REPORT 408A

RECOMMENDATIONS FOR V/STOL HANDLING QUALITIES

(WITH AN ADDENDUM CONTAINING COMMENTS ON THE RECOMMENDATIONS)

OCTOBER 1964

Fig. 1a

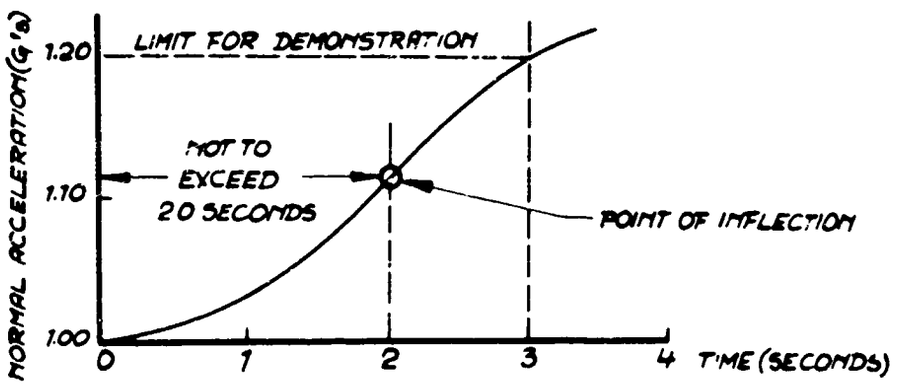
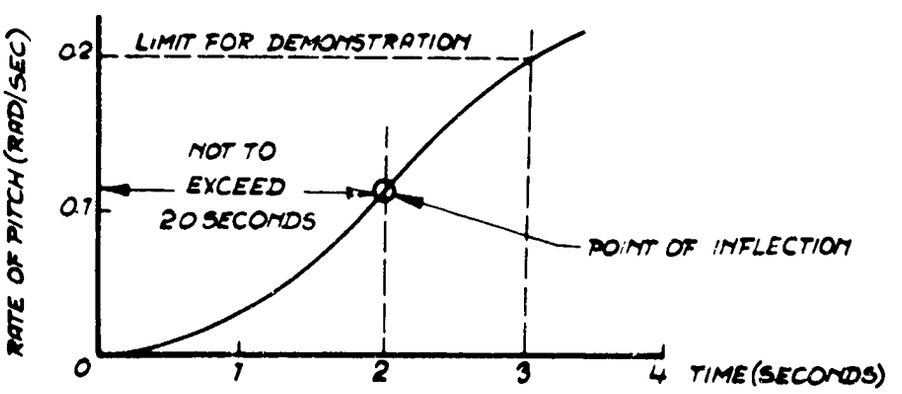
31. Case of initial negative g is not covered. This type of response is characteristic of delta aircraft.

31. No comment.

Fig.2

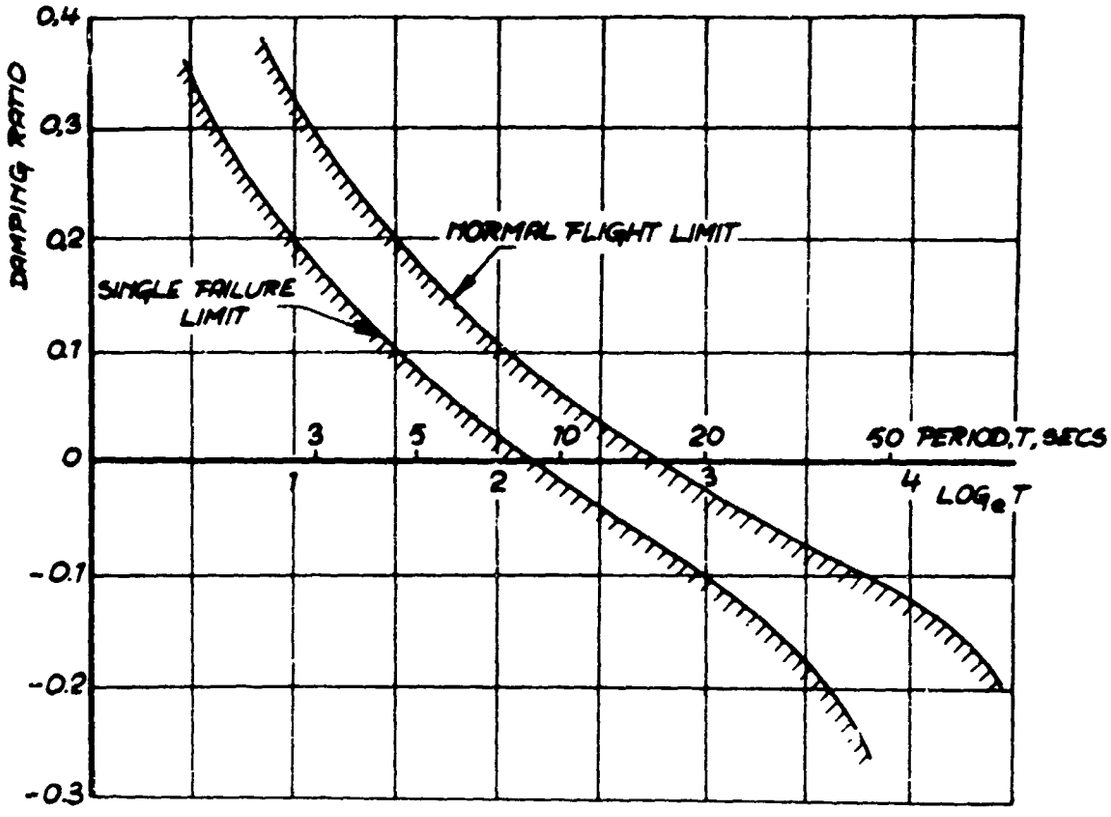
34. For conventional ILS approaches, longitudinal short-period oscillations in the 5-15 sec range are a problem area. In this range an increase in damping is required. Possibly this effect is more prominent in conventional flight because of stronger g-response. Nevertheless the present recommendation seems an oversimplification.

Discussion:
Might be result of g-response in conventional aircraft. VTOL different. In any case present recommendations probably oversimplification. -

34. Recent tests at our establishment suggest the damping ratios specified do not appear adequate even for visual approaches. For example, our tests suggest the damping ratio should be about 0.4 for a 12-second period, but in general our results showed that the damping requirements were primarily related to the gust response. If the damping was sufficient to adequately reduce the gust response, the damping ratio of the oscillatory mode (directional) was much higher than that given by Figure 2.
